Product / Process Change Notification (PCN)

PCN #: PCN_IndHIDA_20210824

Affected Series: WE-HIDA; 7444011480xxx

**DETAIL OF CHANGE:****Design:****Before Change**

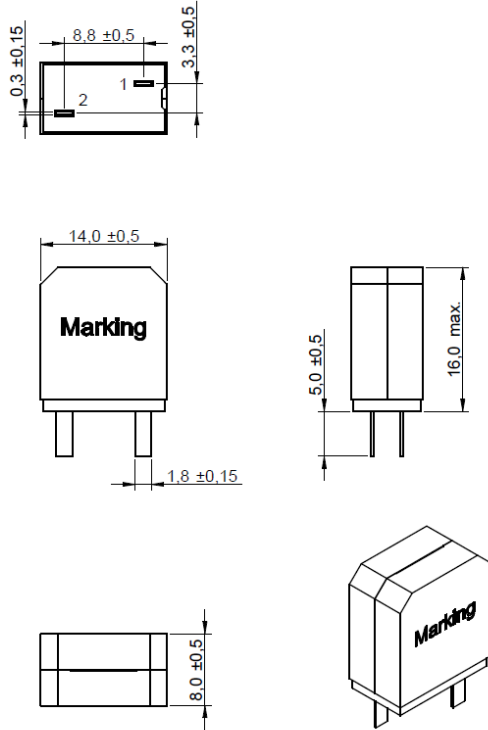
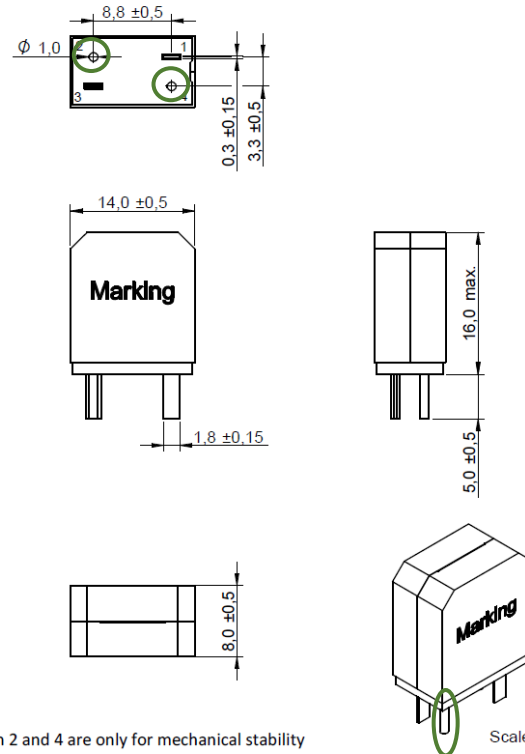
In order to enhance the product reliability, Würth Elektronik will add two round wire pins to all products of the size 1480. Therefore the Dimensions, Recommended Hole Pattern and Schematic drawings are updated. In addition the certifications on the datasheet will be update with the AEC-Q200 Grade 1 information.
